25-75DA Family Promise Staff Report

Address:	430 & 460 Substation Road
Request:	Requesting relief from Sec. 87-4.3 requiring a type 5 buffer on the western property line
Owner/Applicant:	Family Promise of South Sarasota County, Inc.
Agent:	Melanie Smith, PE - Mel-Haven Engineering, LLC
Parcel ID:	0407100014, 0407100005
Parcel Size:	2.27± acres (Phase 1: 1.01± ac)
Future Land Use:	High Density Residential
Zoning:	Residential, Multifamily 1 (RMF-1)
Comprehensive Plan Neighborhood:	Gateway
Application Date:	December 1, 2025
Associated Petition:	25-74SP

Landscape Plan (western property line)

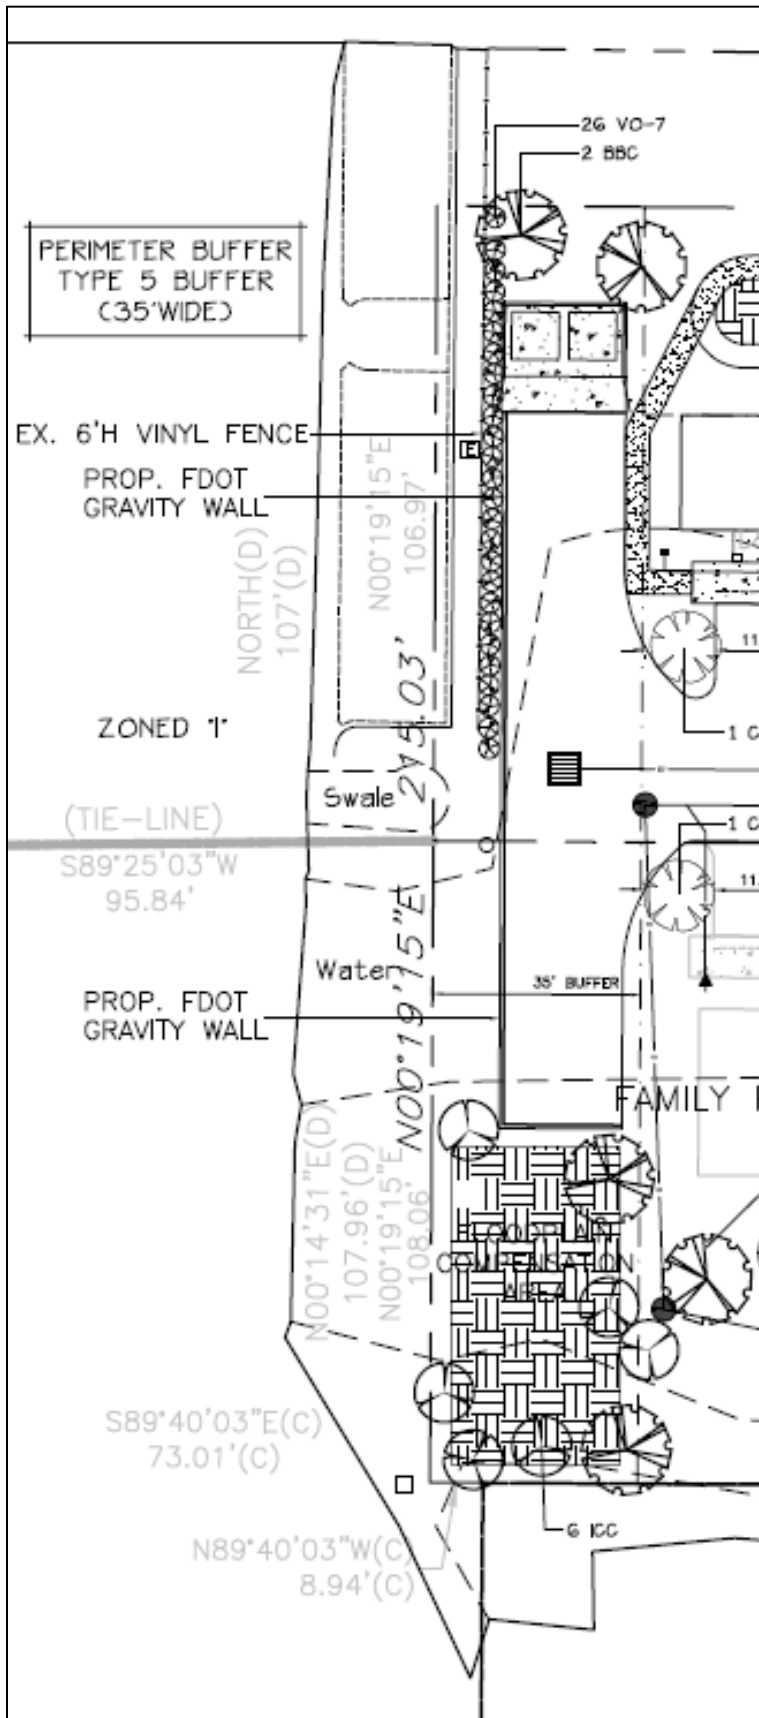
The provided landscaping on the western side of the project is proposed as follows, including the applicant's comparison to the typical requirement:

<u>WEST PROPERTY LINE TYPE 5 BUFFER 35'wide)</u>			
per Design Alternative Petition 25-75DA			
6 Trees / 100 lin. ft.			
3 Understory Trees / 100 lin. ft.			
Continuous Hedge			
6'h Wall			
3'h Berm			
HARDSHIP RELIEF: Existing property encroachment, existing brackish water / Mangroves and existing 6'h 100% Opaque Vinyl Fence			
215 l.f. / 100 = 2.1			
2.1 x 6 = 12.6		13	TREES REQUIRED
2.1 x 3 = 6.3		7	UNDERSTORY TREES REQUIRED
			CONTINUOUS HEDGE
5	BBC	Shady Lady Bl. Olive Tree 12'h x 6'spr., 3"cal.	5 TREES PROPOSED
6	ICC	Dahoon Holly Tree 8'-10'h x 4'spr., 2.5"cal.	6 UNDERSTORY TREES PROPOSED
26	V0-7	Sweet Viburnum 36"h, 7 gal.	26 SHRUBS PROPOSED

Summary Staff Comment: Buffers are a major part of the compatibility considerations in the Land Development Code. The intent of requiring a Type 5 buffer between industrial and residential is typically for protection of the residential use from incompatible neighbors. Turbine Weld to the east was already given a design alternative due to the low impact of their parking and stormwater area on the adjacent Family Promise property, and this residential applicant has expressed that there are no concerns about potential nuisances if these buffer standards are reduced. There are no other modifications requested and this request aims to allow a design for 25-75SP that is otherwise compliant with all aspects of the LDC.

Neighboring buffer

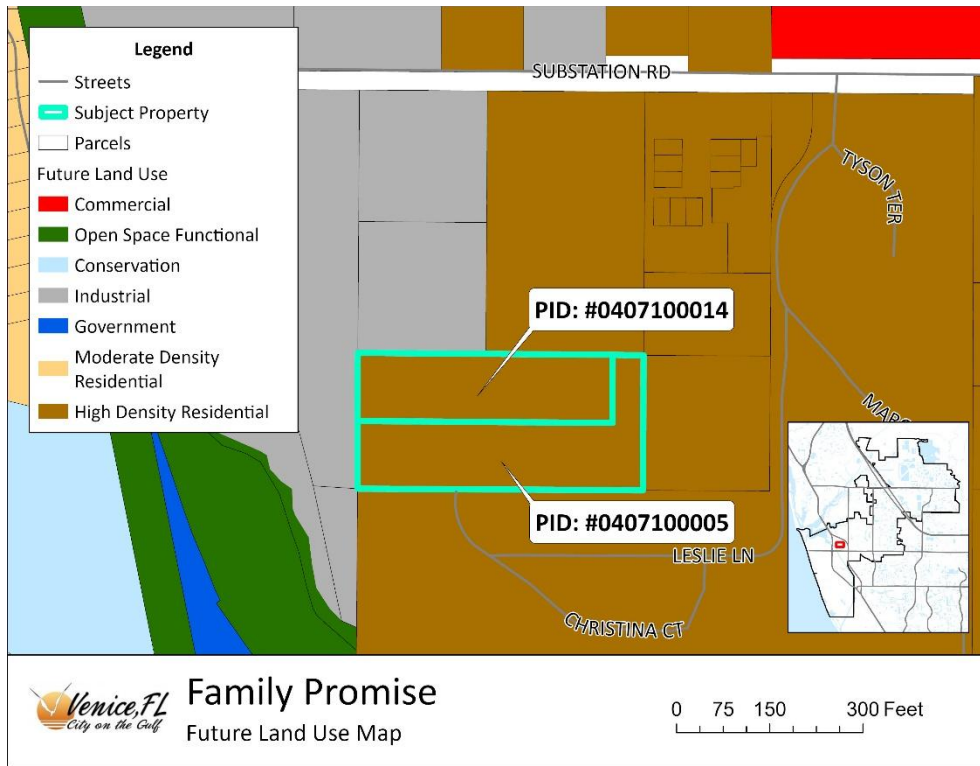
The applicant states in their narrative that the adjacent buffer for VSE Aviation (formerly Turbine Weld), the industrial user to the west, which was also granted a design alternative (24-27DA) due to size constraints, is sufficient for their project. That buffer does not contain a wall or a berm, but does have a fence, and is narrower than the 35' standard. The western part of the subject site is the location of a T-turnaround and dumpster enclosure, and on the neighboring site, the eastern portion is parking and stormwater with vegetation. Family Promise does not have a desire for additional buffering, and typically the intent of requiring a Type 5 buffer between industrial and residential is to protect the residents from industrial nuisances.
